1st September 1885, No. 986, Revenue.

Taluk Cutcherry (2nd Class) at Manantoddy.

Plan Se on and Elevation
of the
Taluq Cutcherry at Manantoddy

Taluq Cutchery at Manantoddy

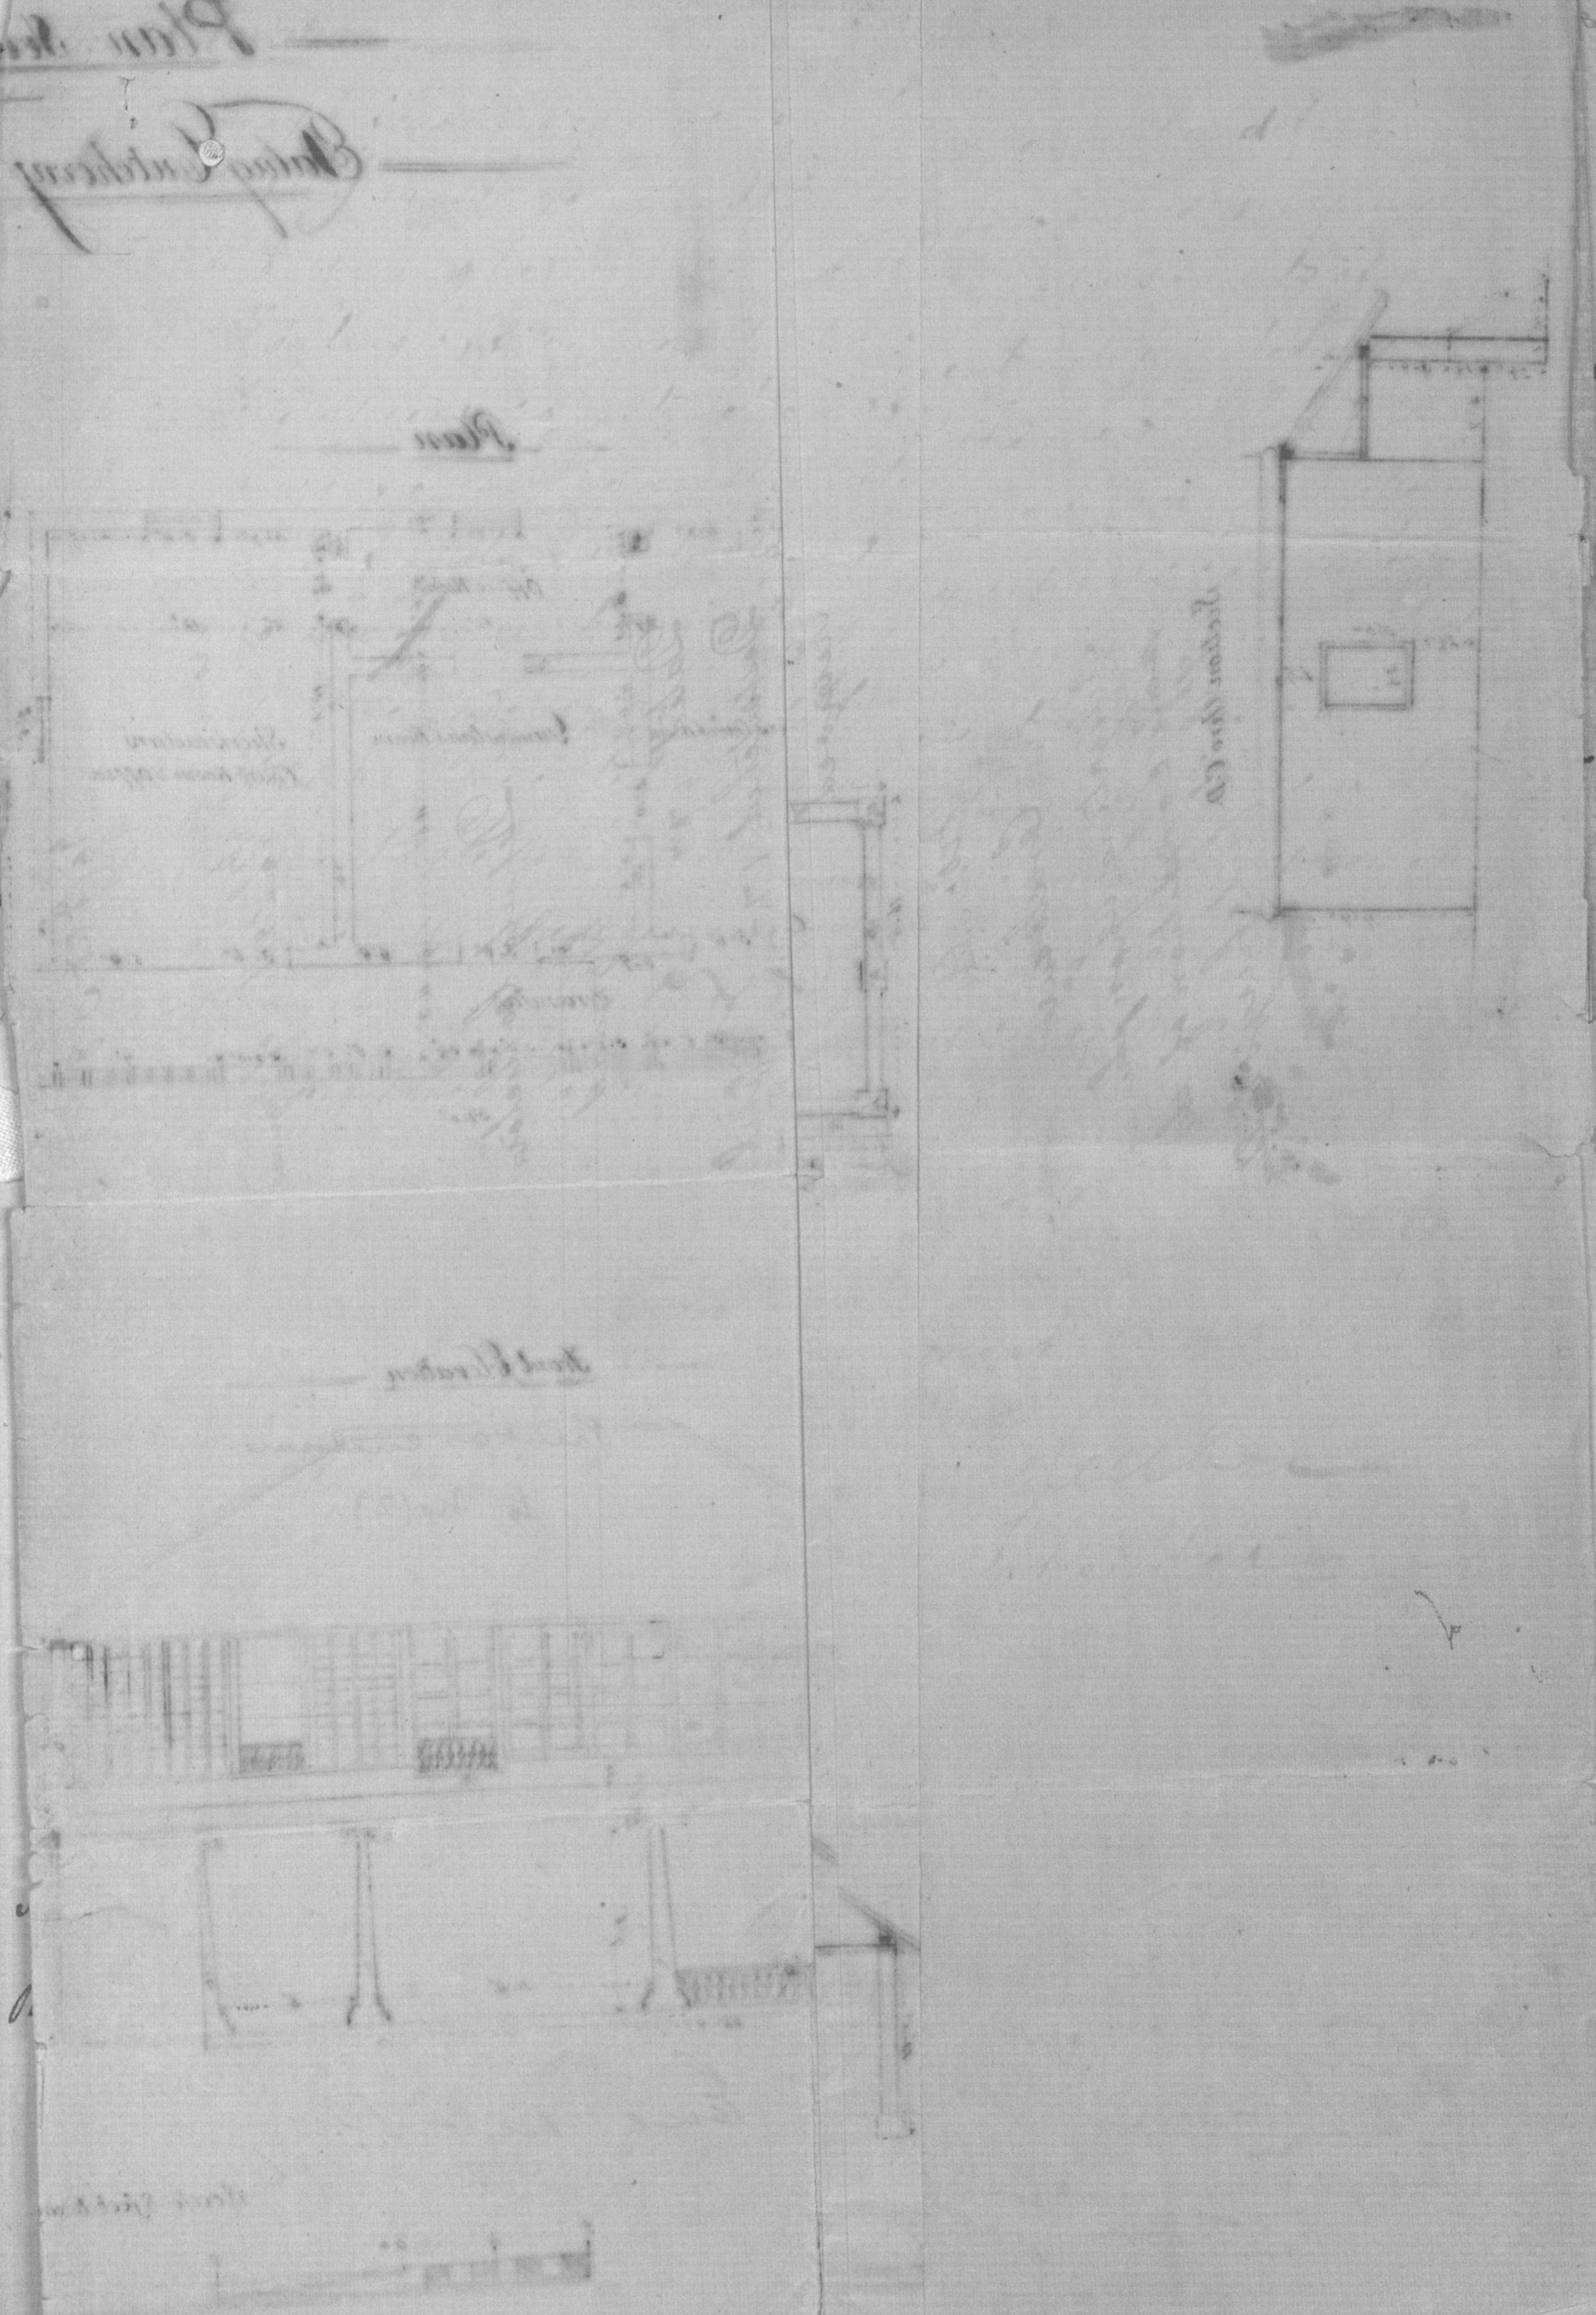
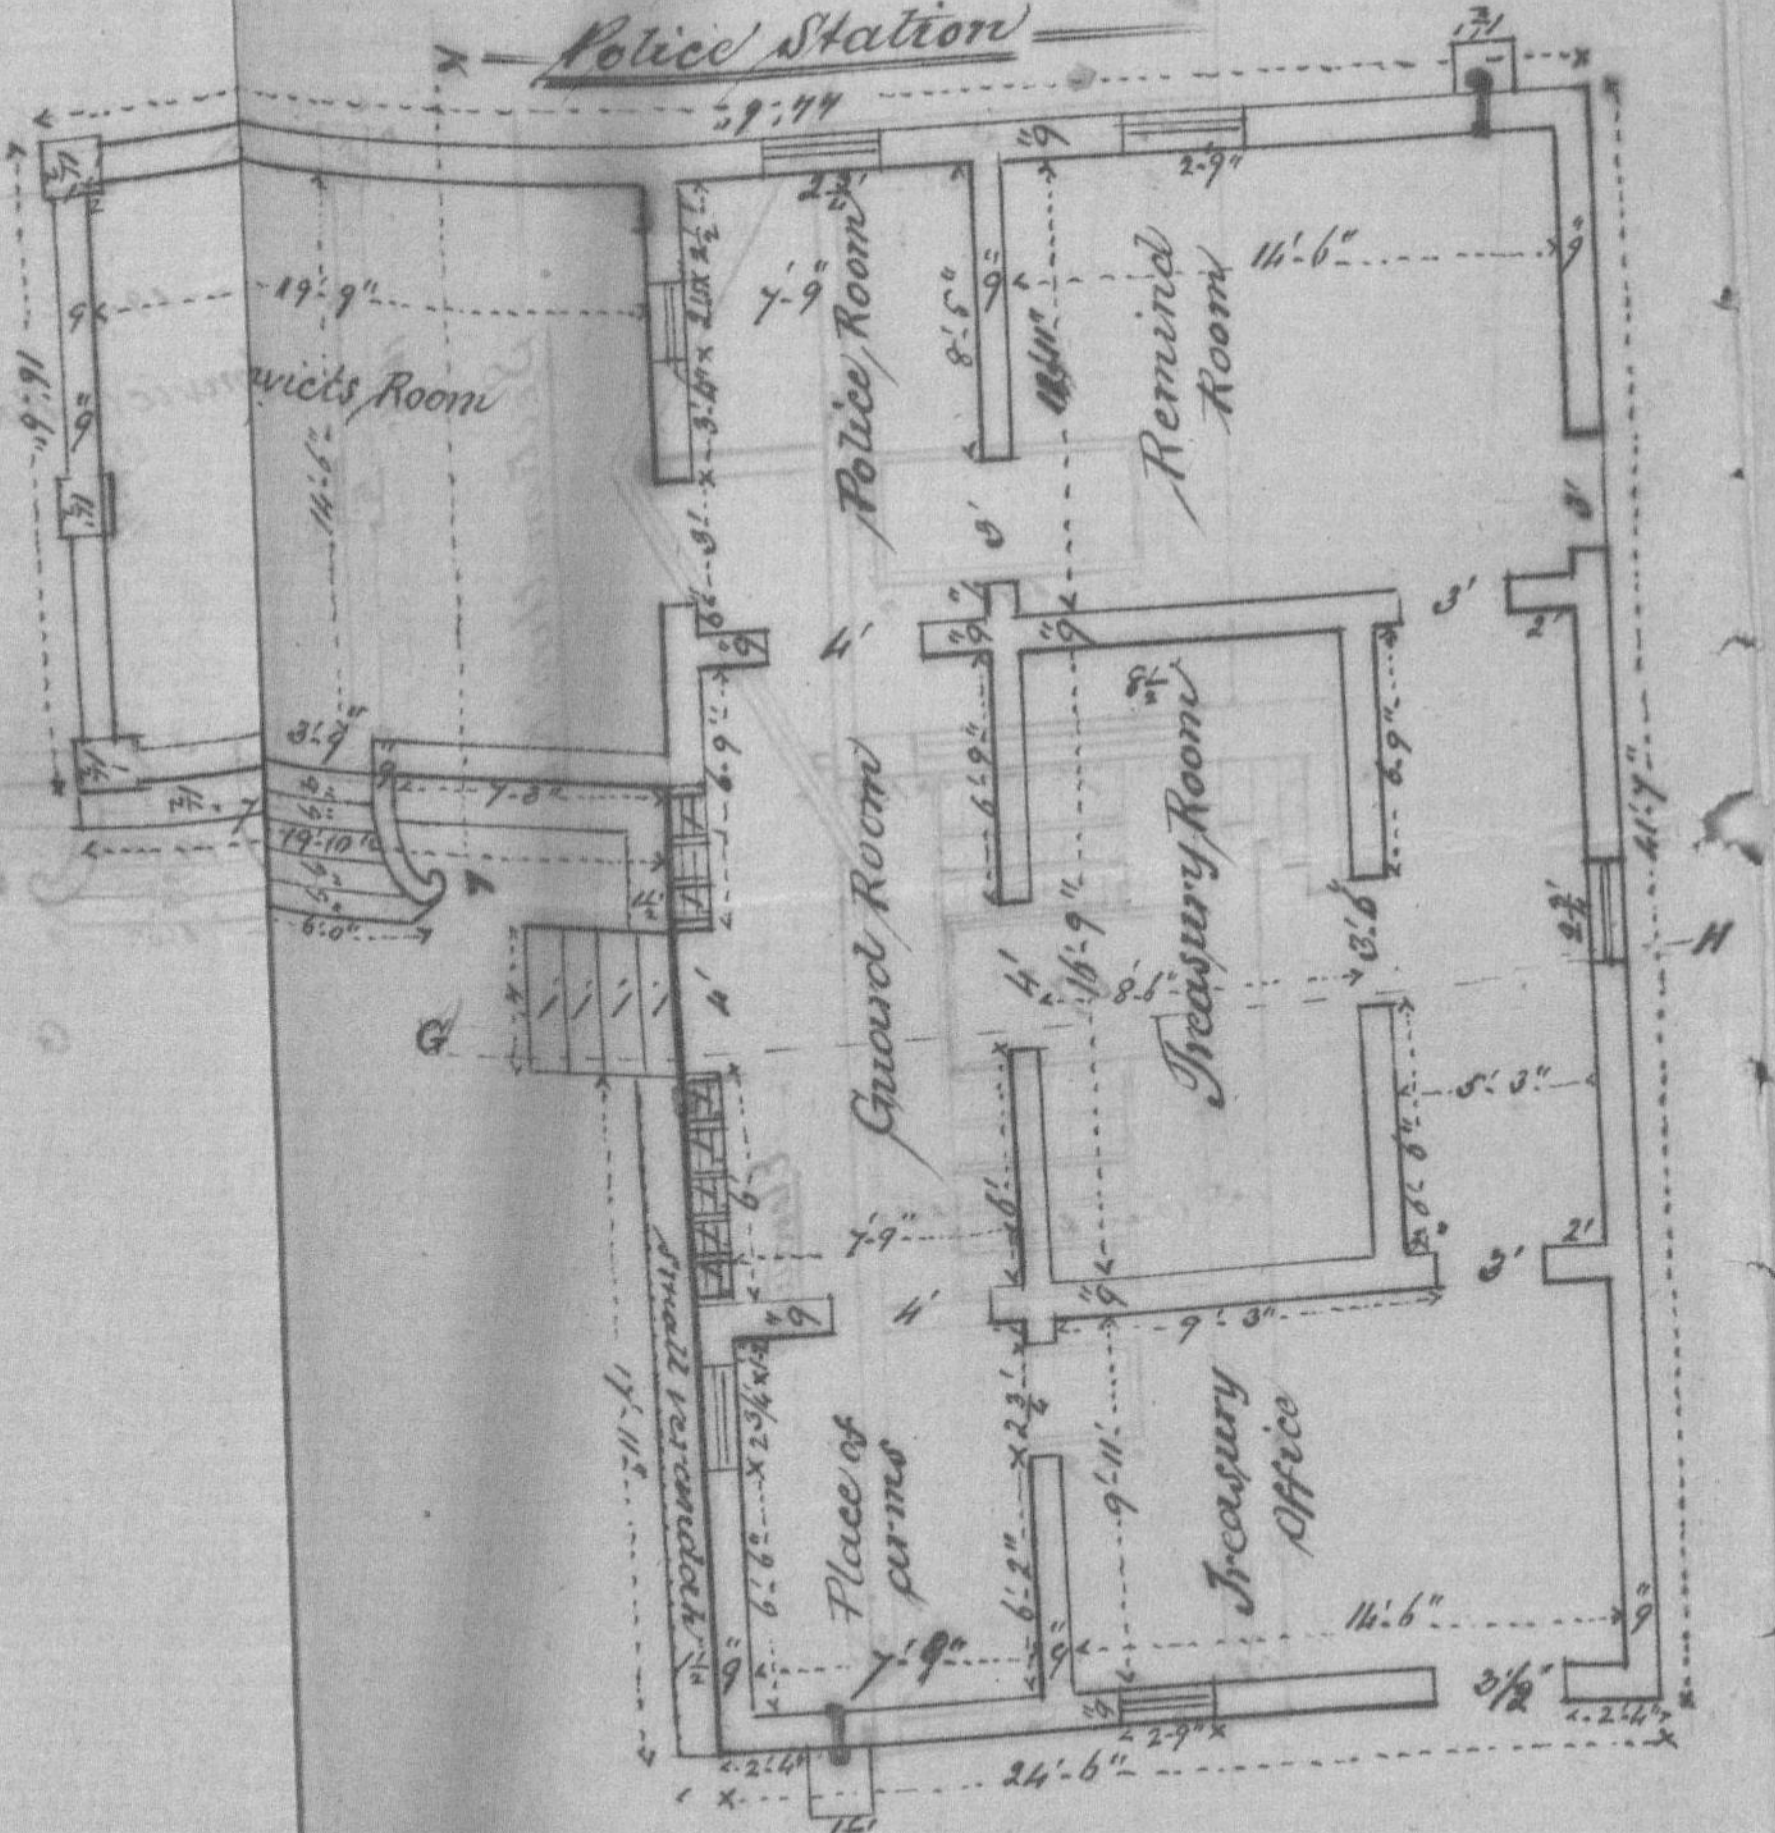
(4) The rooms are so low and ill-ventilated as to be sometimes almost stifling. Owing to the small size of the doors, even ordinary almirahs cannot be taken into them. The lighting is so bad that the clerks have to use lamps on cloudy days. Also owing to weakness of construction the whole building shakes in any strong wind;

(5) The treasury being in a detached building with no covered way between it and the main building, the Tahsildar and his establishment are subject to great inconvenience in rainy weather in passing to and fro between it and the main building;

(6) The treasury, sub-jail, and police station are very insecure, in a dilapidated shaky condition, and infested with rats and snakes. The walls are so weak that prisoners have escaped by breaking holes in them, and a mad prisoner kicked down one of them. The arrangement of the rooms is so bad that efficient guarding is impossible, and the treasury room is so dark that a lighted torch is required when entering it even on a bright summer's day.

(7) Finally, the buildings are stated to be in such a tottering condition that they will probably collapse, either entirely or in part, during the present monsoon.

3. From personal inspection I can certify that the Tahsildar has not in any way misrepresented the state of the building, and it will, I think, be manifest that it would be waste of money attempting to repair and improve it.

4. I request permission to submit plans and estimates for a new second-class cutcherry.
